Staff Report

Knoxville Historic Zoning Commission

File Number: 7-B-26-HZ

Location: 1318 Armstrong Ave. **Parcel ID:** 81 L F 024
District: Old North Knoxville H
Zoning: RN-2 (Single-Family Residential Neighborhood)
Description: Craftsman, c.1915

Three non-historic
windows in office (south
elevation)

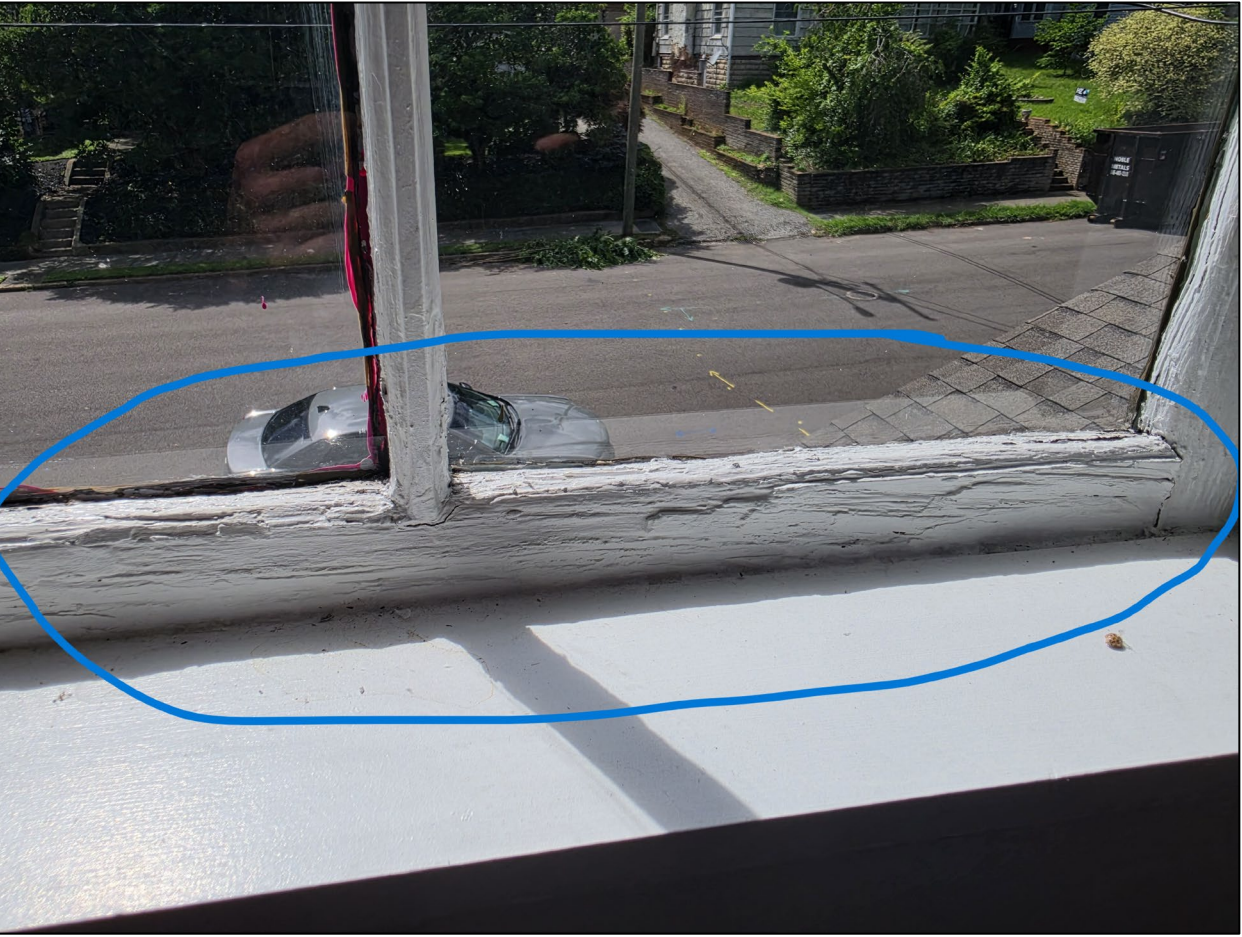
1. 1318 Armstrong Ave is a contributing resource to the Old North Knoxville National Register Historic District and local overlay.
2. All of the windows proposed for replacement are original or historic, except for four 6-light windows on the right side of the south elevation. Previous COAs document repairs to the original windows. The application contains extensive documentation of exterior and interior wood rot, warped sashes and inoperable windows. Replacement of the windows is appropriate within the guidelines.
3. Old North Knoxville's design guidelines recommend that replacement windows "shall be the same size, with the same pane division and muntin depth, width, and profile as the original. They shall be the same materials as the original windows, which were generally wood."
